## Lloyd's Register of Shipping.

Ship's Name "APPLELEAF"

Official No. 140251

Memorandum of alterations reported since ship was surveyed for assignment of Load Lines in Chatham

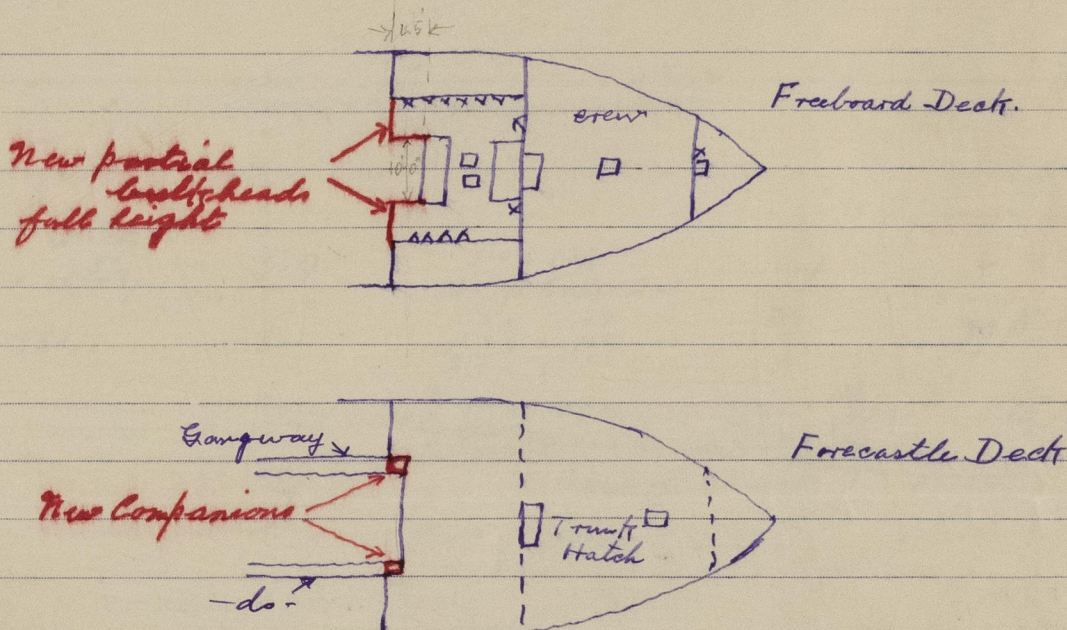
- (1) New partial bulkheads, plating .30", stiffeners 3"x 3"x .30" angles, spaced 30", now fitted, enclosing openings in forecastle bulkhead as shown in sketch below, Forecastle bulkhead now has "No openings" and the Load Line Certificate has been changed accordingly.
- (2) Two steel companions 4'-6" x 3'-4" x 6'-6" high, plating .30" suitably stiffened, fitted on forecastle deck leading to crew's quarters. Watertight doors of steel, strongly constructed, can be operated from both sides, sill 12".
